APPL-23-0007, WILSON TANK HEIGHT INCREASE APPEAL

CITY COUNCIL

November 14, 2023

WATER STORAGE TANK – HEIGHT INCREASE COMPARISON

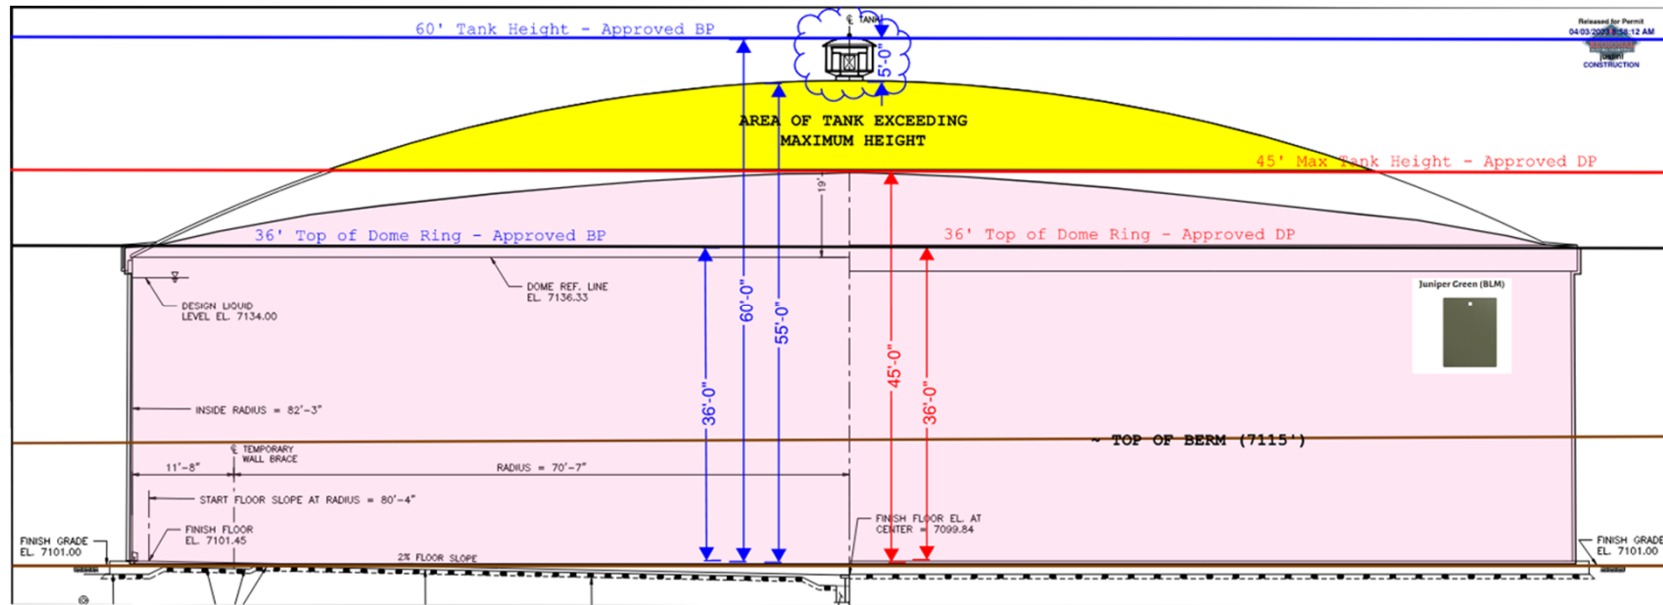
City Planning Commission denied the Wilson Tank Height Increase Development Plan Major Modification and determined that the application did not meet the applicable review criteria:

- Created more adverse impacts on surrounding properties than the approved development plan be required, such as a screen wall and robust shrub planting.
- Not consistent with PlanCOS, specifically citing the Majestic Landscape Framework.

1. The size range of 25' – 35' listed for the larger Ponderosa Pine or Colorado Blue Spruce trees in the Plant Schedule under the Botanical/Common Name column that is contained on the Landscape Plan is revised to 25' HGT. MIN. to match the Size/Cal. column.

2. The designer of record for the Landscape Plan must be present at the nursery at the time the larger, 25 feet minimum height Ponderosa Pine or Colorado Blue Spruce trees are selected to document that the trees meet the minimum required height as specified by the Landscape Plan. This is to be documented by a photographic verification and written affidavit showing that each selected tree meets the minimum height before being planted.

3. A height survey verification for the water storage tank is required to be provided from a licensed professional surveyor in the State of Colorado prior to any zoning final inspection.

4. Financial Assurance shall be put in place for the Landscape Plan and Irrigation Plan improvements prior to any zoning final inspection.
5. The water tank color is revised to Juniper Green.

6. The landscape plan is revised to include six (6) additional 25 feet minimum height Ponderosa Pine or Colorado Blue Spring in the southwest corner of the site (see illustration on Page 11, City Planning Commission Staff Report).
